FORD:
2009-2010 Escape

MERCURY:
2009-2010 Mariner

Some 2009-2010 Escape Hybrid and Mariner Hybrid vehicles built on or before 8/10/2009 may exhibit a slightly louder than normal drone/moan noise on acceleration at approximately 1800-2300 RPM.

TSB 09-22-19 (Continued)

Figure 1 - Article 09-22-19

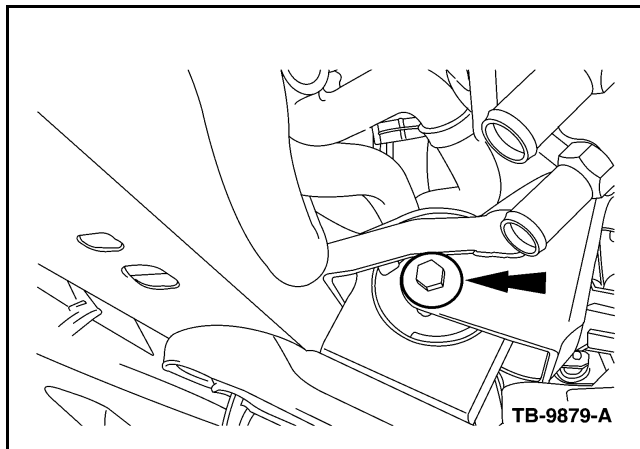
1. Disable the vehicle high voltage electrical system following Workshop Manual (WSM), Section 414-03 High voltage traction battery systems depowering.
2. Remove the lower transaxle insulator through bolt. (Figure 1)

6. Install the rear roll restrictor-to-crossmember through bolt. Tighten to 66 lb-ft. (90 N•m). (Figure 2)
7. Install the lower transaxle insulator through bolt. Tighten to 85 lb-ft. (115 N•m). (Figure 1)
8. Enable the vehicle high voltage electrical system following WSM, Section 414-03.

Figure 2 - Article 09-22-19

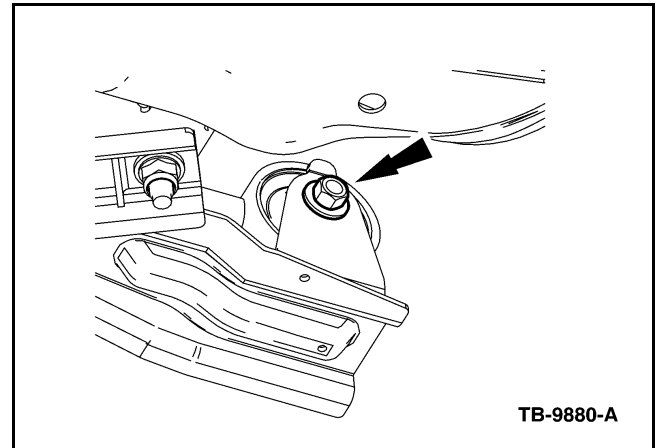
3. Remove the rear roll restrictor-to-crossmember through bolt. (Figure 2)

Figure 3 - Article 09-22-19

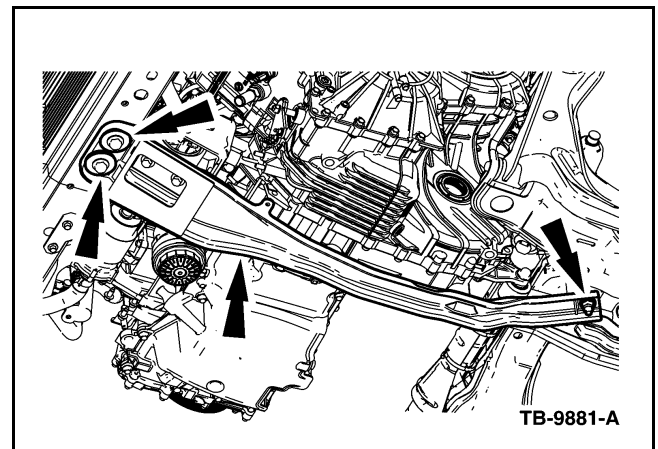
4. Remove the nut, bolts and engine support crossmember. Discard the nut. (Figure 3)

5. Replace the engine support crossmember with improved service level crossmember. Tighten the bolts to 66 lb-ft. (90 N•m), tighten the new nut to 129 lb-ft. (175 N•m). (Figure 3)
